**Flood Control Project Maintenance
Levee Inspections**
LMA District Cover Sheet
Spring 2018 Levee Inspection Results

Reclamation District No. 2098 Cache and Haas Slough

Levee Inspection Report By Mile - Spring 2018

Photo 2 of 3 : SP_2018_RD2098_246_15_20180305_00009.jpg

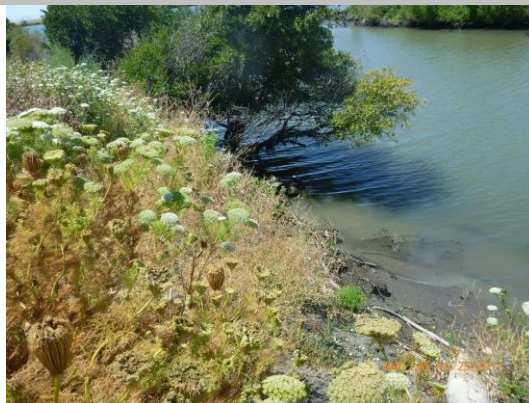
LM Start	6.46	Rating **	A/W	Issue No.	15 (cont)
LM End	6.46	Issue Type +	Ma	Location *	
Category	Supplemental			GPS Latitude/Longitude	
				Start	End
Item	2017 Storm Damage			38.288700 °	38.288800 °
				-121.717000 °	-121.717000 °
DWR ID	DWR_RD2098_02_f _ 2017_15				
Comment Code					
Inspector Comment					
Levee Evaluation Comments					
Description:The damage consists of scour of the lower and mid waterside levee slope.					
Site ID No:440					
Site Designation:LMA-267					
Repair Type: Erosion					
Rating:Area of Concern					
Field Date:7/25/2017					
Notes: Sloughing on waterside slope due to toe erosion.
